# Access Compliance Report

## Public Rights-of-Way

### (Curb Ramps)

Intersection ID: 7457	Main Street: CANTERWOOD_DR	Cross Street: ELGYWOOD_LN	Location: NW
ADA ID: 420A1FFF056F	Ramp Type: BlendTrans1	Initial Pass/Fail: Fail	Overall Compliance: No
Severity Score: 8.75			
Codes/Mitigation Info/Possible Solution		Field Measurements/Component Compliance

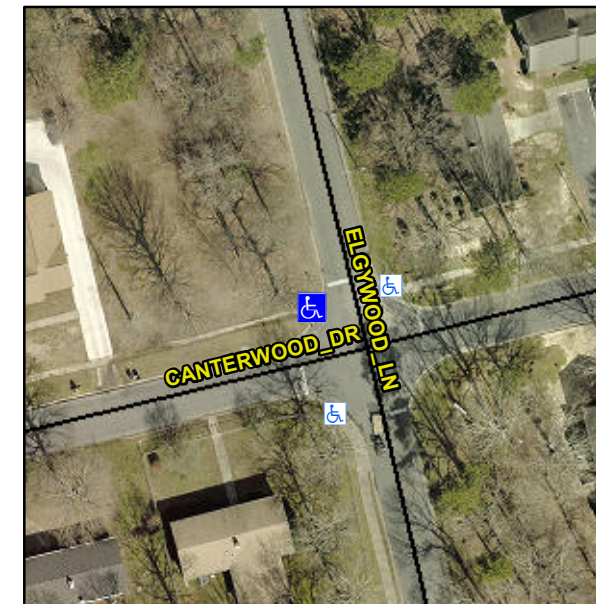
**Not Found, R304.5.1**

Compliance	Description	Data	Compliance	Description	Data
N/A	Ramp Length (in)	81.5	Yes	BlendTrans Slope (%)	2.5
No	Ramp Width (in)	44.0	Yes	BlendTrans XSlope (%)	1.6
N/A	Flare Type LT	N/A	N/A	Flare Type RT	N/A
N/A	Flare Slope LT (%)	N/A	N/A	Flare Slope RT (%)	N/A
N/A	Flare Traversable LT?	N/A	N/A	Flare Traversable RT?	N/A
N/A	Landing Length (in)	N/A	N/A	DWS Provided?	N/A
N/A	Landing Width (in)	N/A	N/A	DWS Contrast?	N/A
N/A	Landing Slope (%)	N/A	N/A	DWS Length (in)	N/A
N/A	Landing X Slope (%)	N/A	N/A	DWS Full Width?	N/A
N/A	Landing Curb? (Y/N)	N/A	N/A	DWS Offset (in)	N/A
N/A	Shared Landing?	N/A			
N/A	Gutter Ponding?	N/A	N/A	Gutter Slope (%)	N/A
N/A	Gutter Lip Ht (in)	N/A	N/A	Gutter X Slope (%)	N/A
N/A	Painted X Walk1?	No	N/A	Painted X Walk2?	No
	X Walk 1 Direction	To SW		X Walk 2 Direction	To E
	X Walk 1 Width (in)	N/A		X Walk 2 Width (in)	N/A
	X Walk 1 Slope (%)	2.5		X Walk 2 Slope (%)	0.9
	X Walk 1 X Slope (%)	0.2		X Walk 2 X Slope (%)	0.2

N/A	Ramp inside XWalk1?	N/A	N/A	Ramp inside XWalk2?	N/A
	Road Slope (%)	1.6		Clear Space?	N/A
	Road X Slope (%)	2.1	N/A	Clear Space to XWalk (in)	N/A
N/A	Any Obstructions?	N/A	N/A	Storm Grate/Utility Hazard?	N/A
	Obstruction Type			Storm Grate/Utility Type	
		N/A			N/A
			Yes	Surface Condition? (G/P)	Good
			No	Curb Slope (%)	11.9

**Remove & Replace Curb Ramp With Two New Directional Ramps or Equivalent.**
